**SECTION 00 90 03
BIDDING AND CONTRACT REQUIREMENTS
ADDENDUM NUMBER 3**

Re: ADDENDUM NUMBER (3) TO THE BIDDING DOCUMENTS FOR

**McHenry County College
University Center at MCC**
Architect's Project Number: 22-050

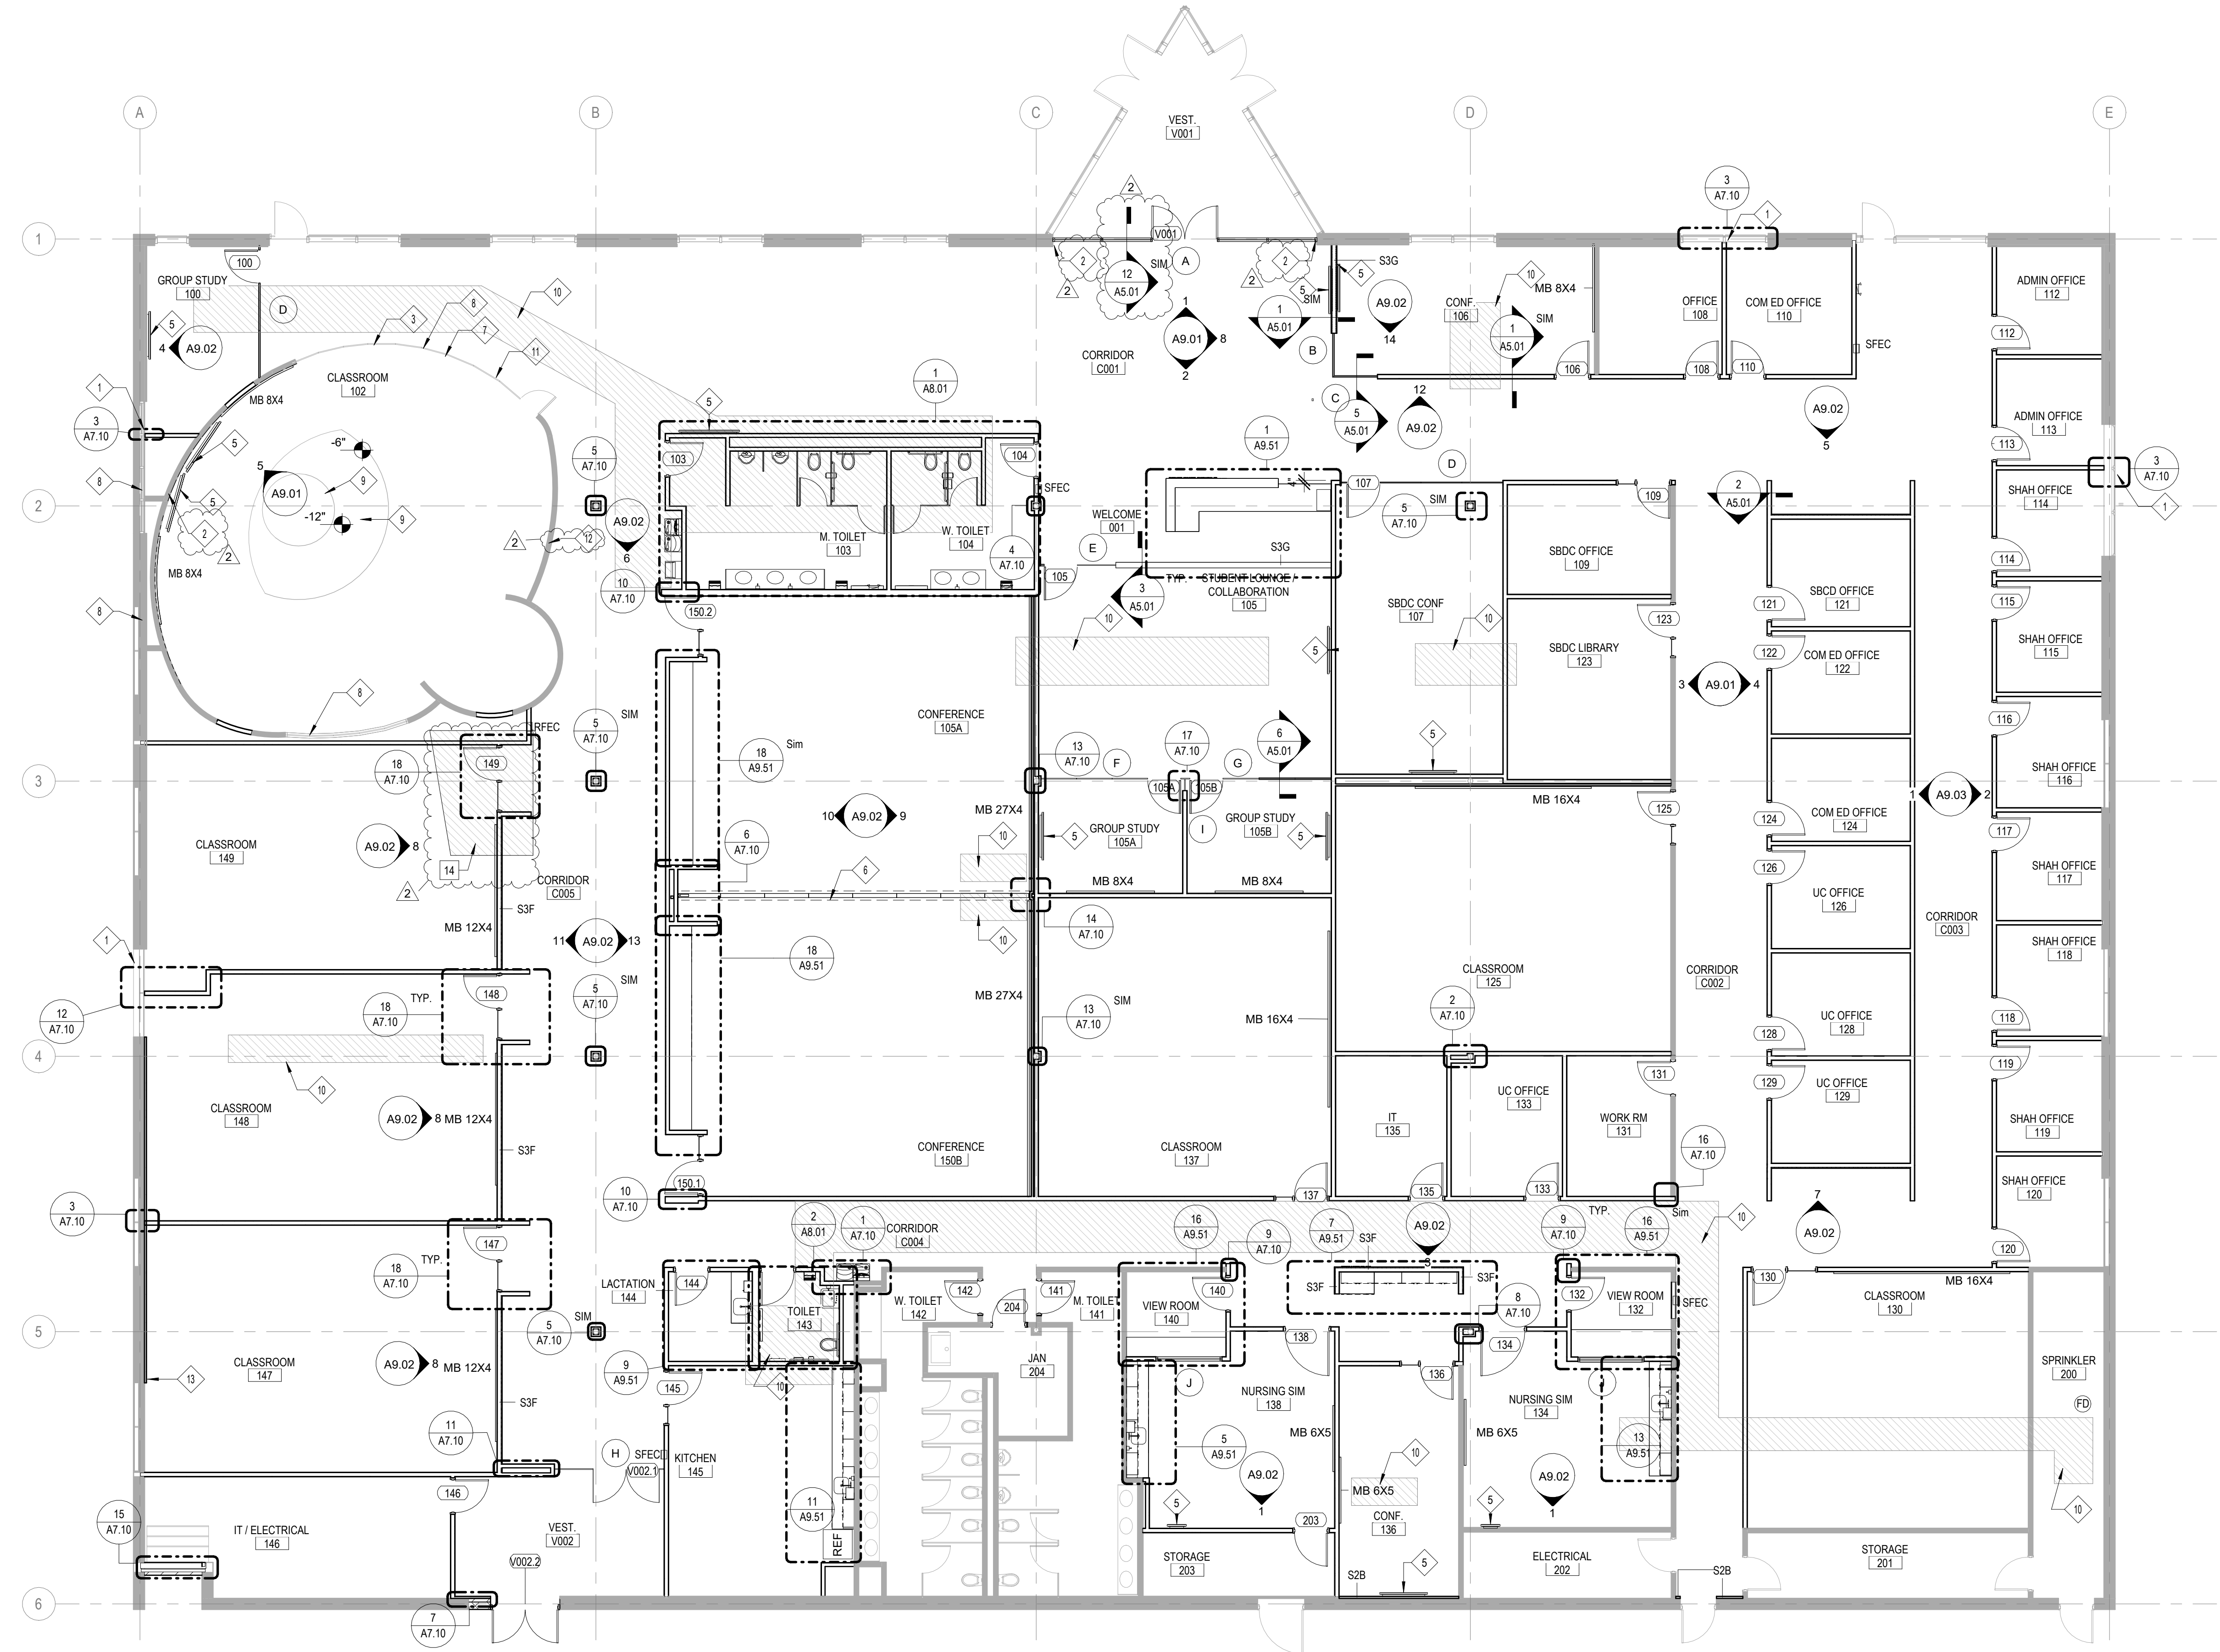
4. A1.11
 - A. **ADD** note 2 as indicated.
 - B. **ADD** note 4 to room 149 as indicated.
 - C. **ADD** note 7 to room 102 as indicated.
 - D. **ADD** note 12 to room 102 as indicated.

- E. **ADD** wall section through window elevation A.
5. A2.11 / A2.51
 - A. **DELETE** note 3 in classroom 102. Contractor to complete work required for new mechanical layout in circular classroom without modification to existing curved ceiling.

SHEET NUMBER:
A2.11

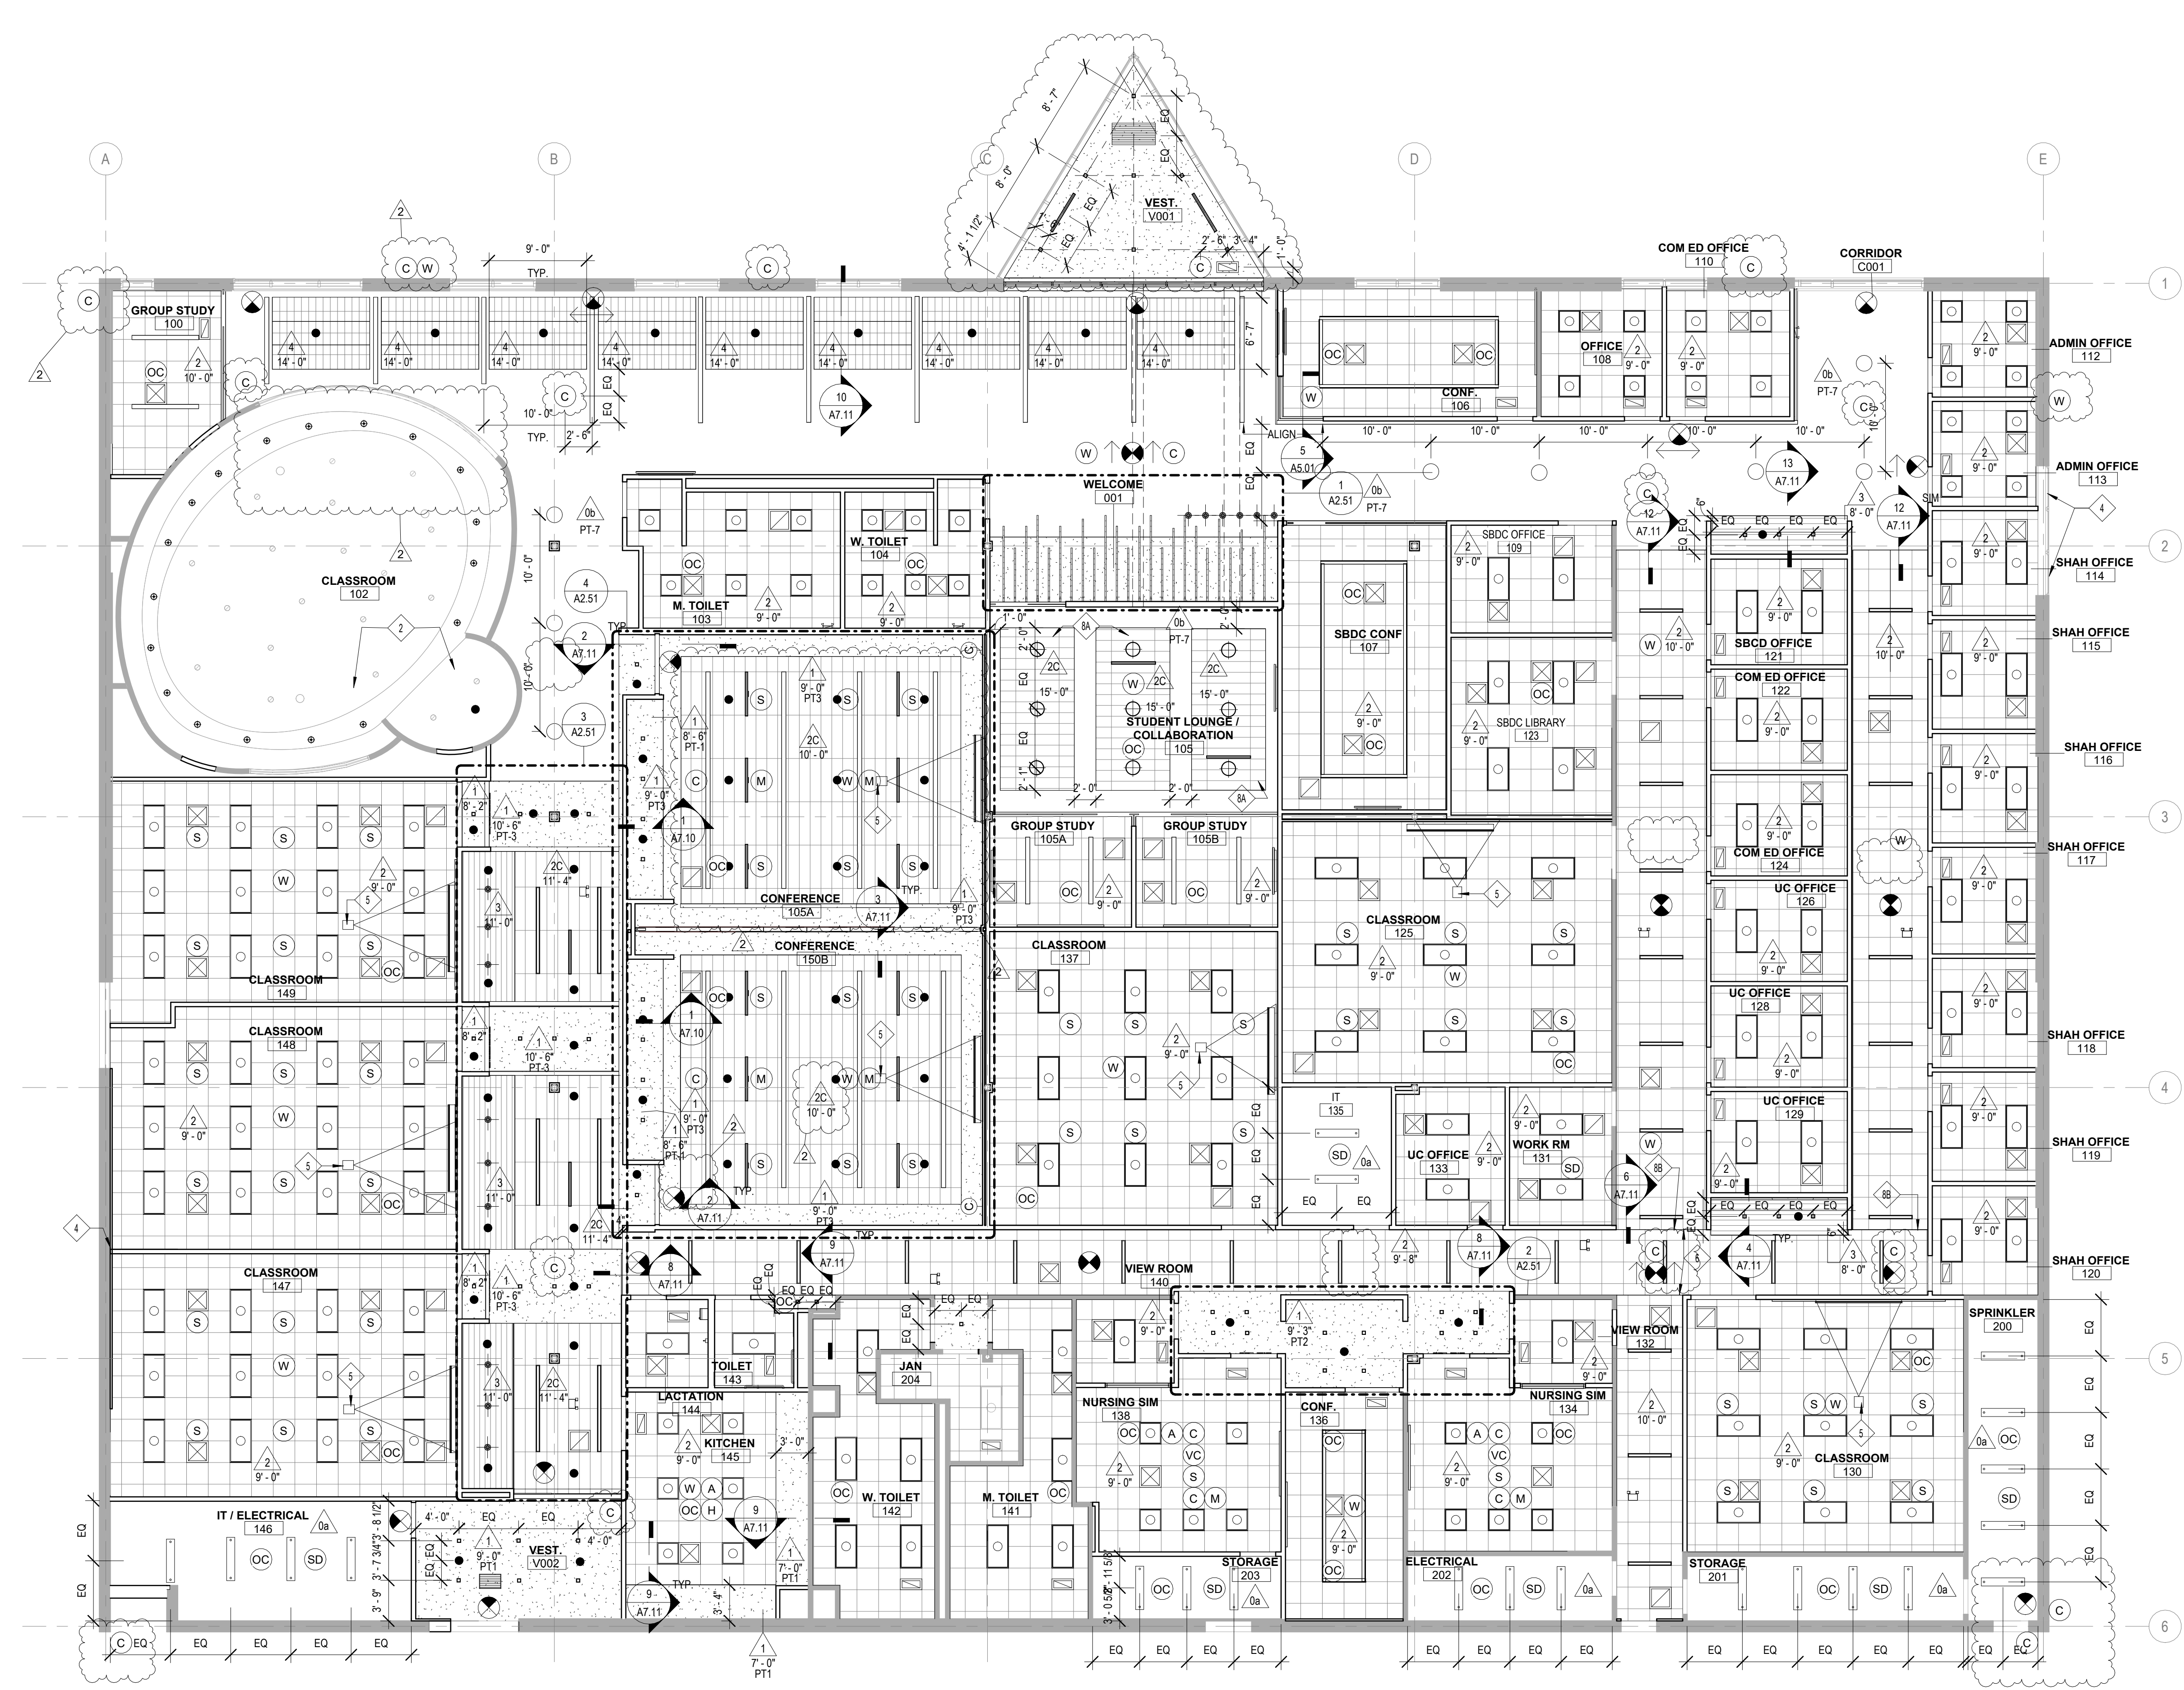
- B. **REVISE** ceiling types in rooms 105A / 105B as indicated.
 - C. **REVISE** layout of sprinkler heads / devices in room 105A as indicated.
 - D. **REVISE** layout of interior / exterior cameras and wireless access points as indicated. Refer to electrical for additional scope details and coordinate final locations with owner / architect prior to installation.

- E. **REVISE** layout of vestibule V001 as indicated.
